**An Evaluation of Flood Frequency Analyses for the Skagit River,
Skagit County, Washington**

*(Responses from the Cities of Burlington and Mount Vernon
shown in italicized blue font)*

**Federal Emergency Management Agency
Region X
Bothell, Washington**

*Responses provided in conjunction with Appeal of the Revised Digital Flood
Insurance Rate Map (rDFIRM) and Revised Flood Insurance Study (rFIS)*

1921 and 2003 flood high water marks surveyed by Stewart (in 1922-23) and USGS (in summer 2004)

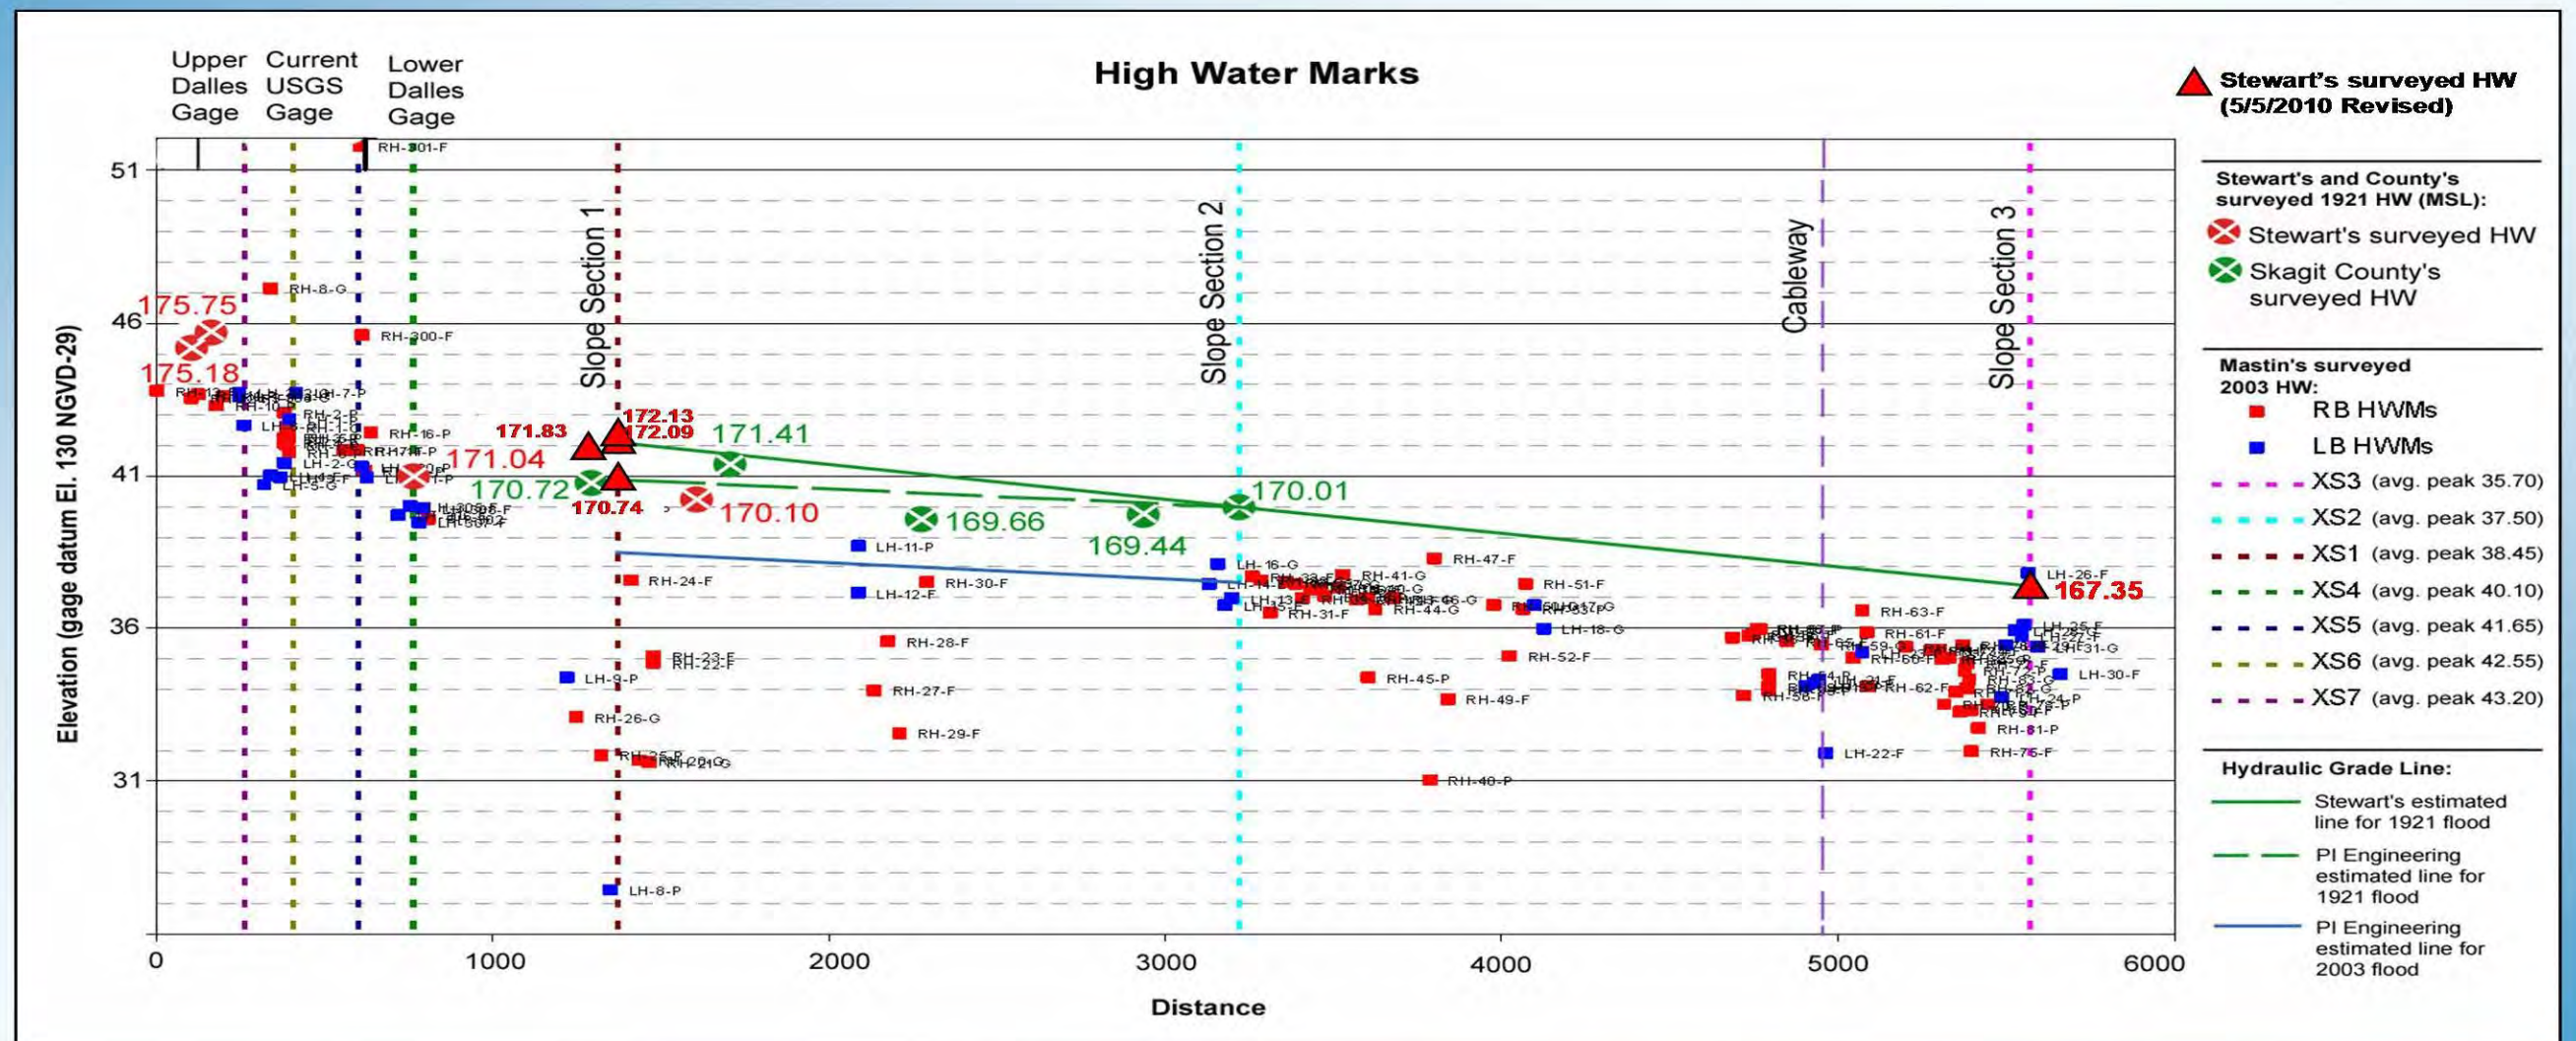
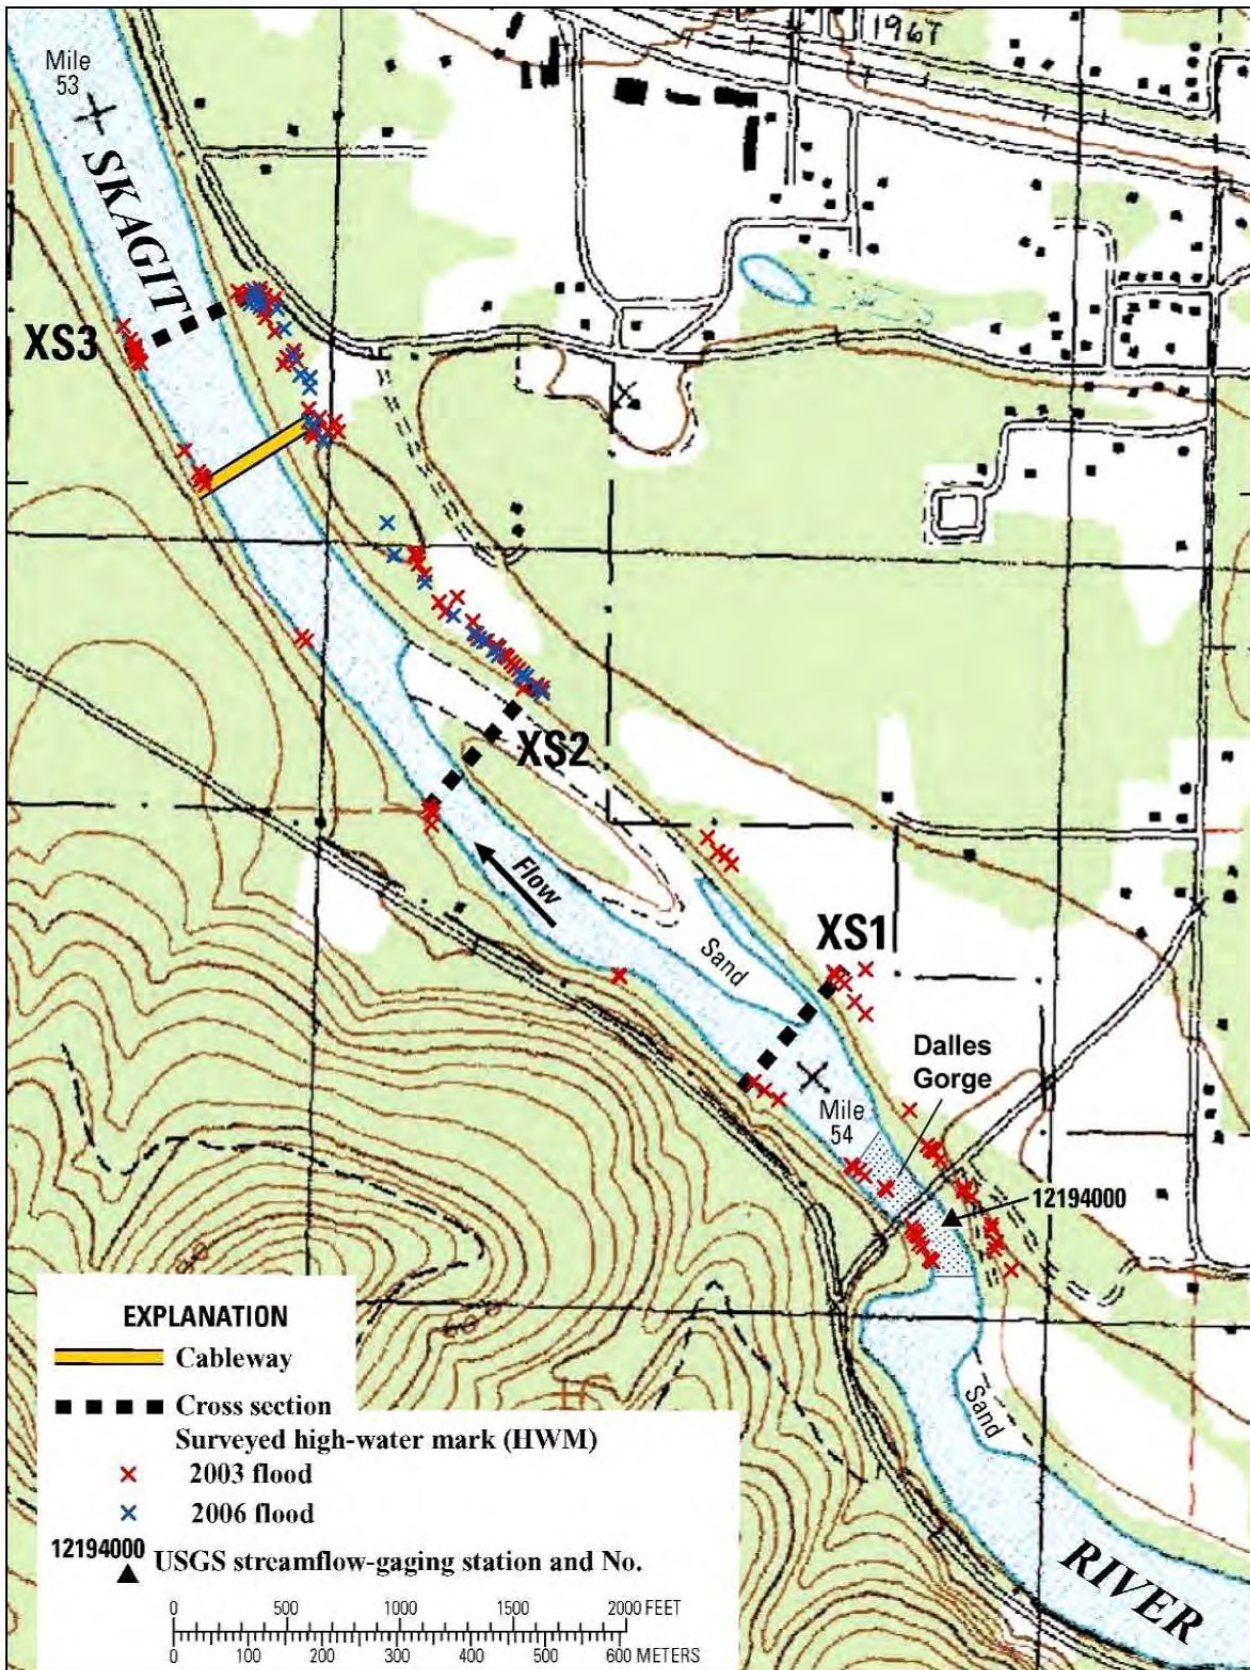
Cities' comment: *Of note is the significant variation in high water marks – as much as several feet to over 10 feet. The report authors attempted to determine a slope from the data gathered, and ultimately decided not to change the previous USGS estimate from this study (240,000 cfs), apparently because of the extreme variation in the high water marks surveyed in 2004. This USGS study demonstrates the difficulty in obtaining accurate high water mark information in the Dalles reach of the Skagit River, where the Concrete gage is located (see map, next page, from USGS SIR 2007.)*

Figure 1: Stewart's 1921 HWMs and water surface profile used in slope area calculations. (Revised from Figure 3 of NHC, March 2010)

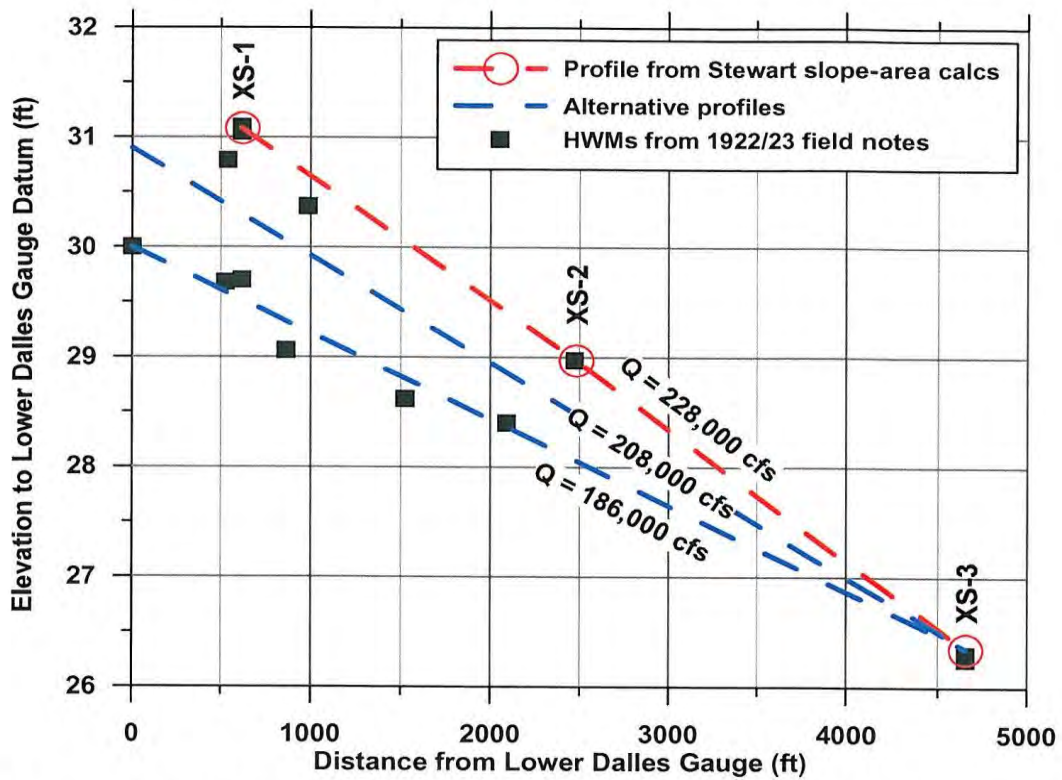
Cities' comment: The figure on the next page shows NHC's plot of all 13 of the high water marks. Although we cannot speak for NHC, we understand the point NHC was making is that there are alternative slopes which are equally as plausible, from the 13 data points provided by Stewart and the supplemental high water mark survey. NHC states in its March 2010 Re-evaluation of the Magnitude of Historic Floods on the Skagit River Near Concrete Revised Final Report, "While the water surface profile for the November 2006 flood is well defined, it provides little guidance for interpretation of the 1921 HWMs. Stewart's slope-area calculations for reach XS2-XS3 assume a water surface slope of 0.0012 compared with a slope of 0.00076 from the November 2006 data downstream from the gravel bar. USGS interpretation of its 2006 data (relying only on HWMs between XS2 and XS3) shows a slope of 0.00114. There is clearly considerable scope for uncertainty in the slope area measurements which strongly suggest that alternative approaches to estimation of the peak should be considered."

Figure 4. High-water marks (HWMs), flattest- and steepest-sloped water-surface profiles, and a HEC-RAS water-surface profile near cross sections XS1, XS2, and XS3, at Skagit River near Concrete, Washington.

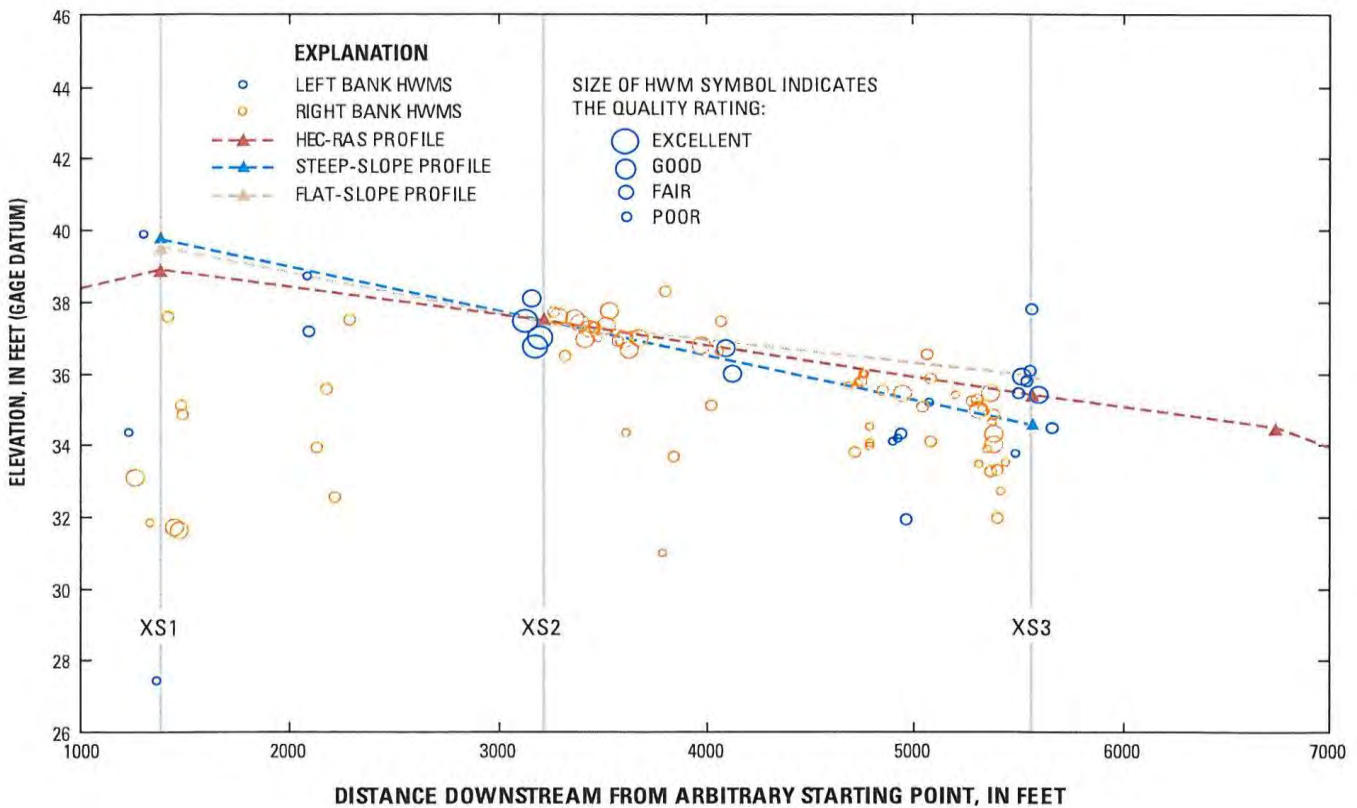
Cities' comment: Stewart surveyed the high water marks 11-13 months after the 1921 flood event, starting in late November and continuing through late January 1922-23. Later, a survey crew from Skagit County surveyed additional high water marks in early March 1923 (such marks presumably marked by Stewart to be surveyed later.) We note that the USGS-surveyed high water marks following the flood of record in October 2003 were surveyed in July-August of 2004, about 10 months following the flood. Shown below is a profile of the high water marks collected and surveyed by USGS in the summer of 2004 following the October 2003 flood of record (USGS SIR 2005-5029, p.8). As can be seen from the plot below, the high water marks in the vicinity of cross section XS2 are well clustered. However, the range of high water marks in the vicinity of XS3 indicate that gathering high water marks in this area was a more difficult task than at XS2. And, in the case of XS1, it is clear the difficulty of gathering accurate high water marks is very challenging, likely due to surge effects during the flood itself, and also due to the time interval between the flood and the data collection. We observe that the right bank marks rated "good" are 5-8 feet below the expected water surface elevation. Two left bank marks, both rated "poor," are over 5 feet different.

Figure 3. Comparison of unregulated and regulated frequency curves for the Skagit River near Concrete, WA as developed by PIE (2008).

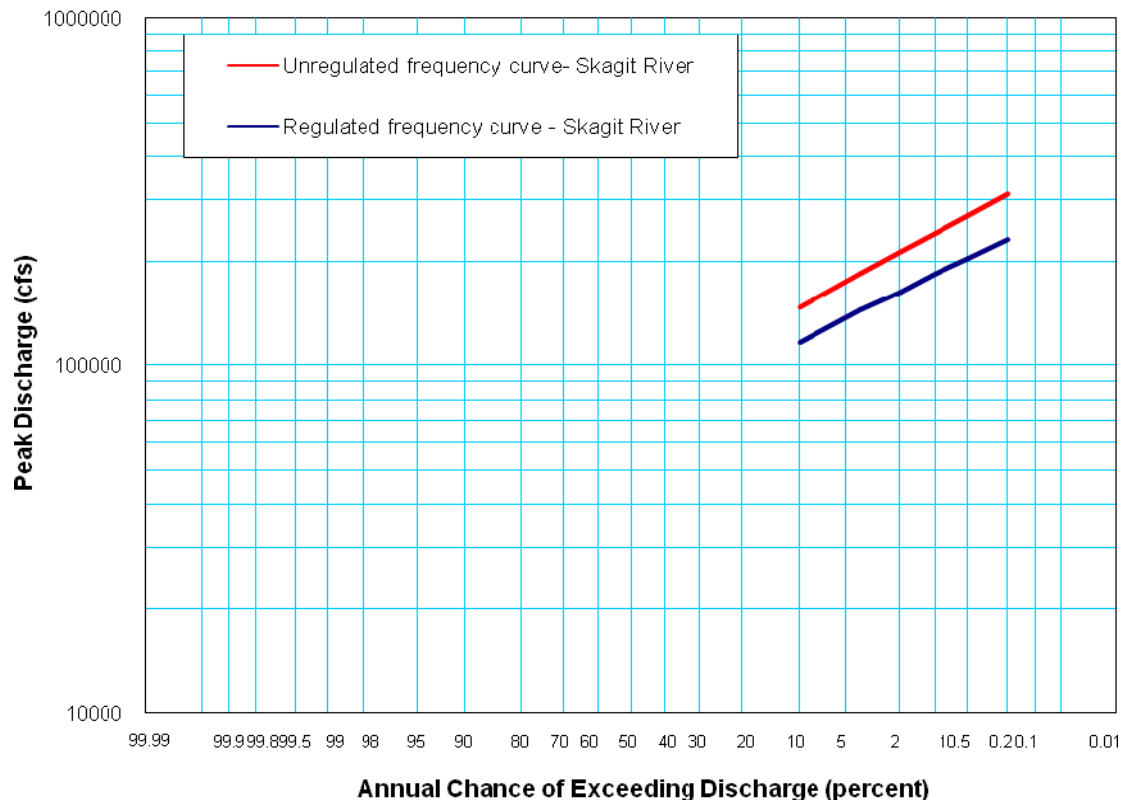
As shown in Table 3, the ratio of the regulated to unregulated flood discharges for the PIE analysis is actually decreasing as the flood event becomes more extreme while the USACE ratio increases as it should. As the magnitude of the flood event increases and the flood storage in the reservoirs decreases, the regulated and unregulated flood discharges should converge. At the 0.2-percent annual chance event, the PIE (2008) unregulated and regulated frequency curves are still diverging. This is illustrated in Figure 3. The skew for the PIE (2008) regulated frequency curve is about -0.35 and -0.142 for the unregulated curve implying they are diverging.

The diverging of the regulated and unregulated frequency curves was prevalent in an earlier 2005 analysis performed by PIE. This issue was discussed in a February 2006 review by FEMA. In response to the FEMA 2006 review, PIE pointed out that their 2005 frequency curves would converge at about 4 times the 1-percent annual chance flood discharge. This may also be the case for the PIE (2008) analysis that the frequency curves will converge for some very large flood event. However, it seems the PIE (2008) regulated and unregulated frequency curves should be converging for a large flood like the 0.2-percent chance flood given the dedicated flood storage (71 acre-feet per square mile) in the Skagit River watershed.

Cities' comment: *The above simplistic analysis is inaccurate. See PI Engineering's March 2011 report, section 2.6.*
